Access Compliance Report

Public Rights-of-Way

Intersection ID: 10041630	Main Street: WHITEHALL_PARK_DR	Cross Street: N/A	Location: NE
ADA ID: 778C8137E9FE	Ramp Type: BlendTrans1	Initial Pass/Fail: Fail	Overall Compliance: No
Severity Score: 8.75			
Codes/Mitigation Info/Possible Solution		Field Measurements/Component Compliance

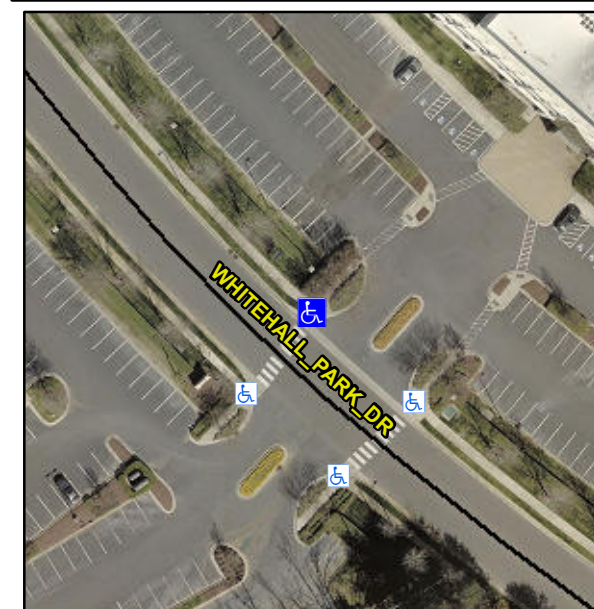
Remove & Replace Curb Ramp With Two New Directional Ramps or Equivalent.

Not Found, R304.5.1
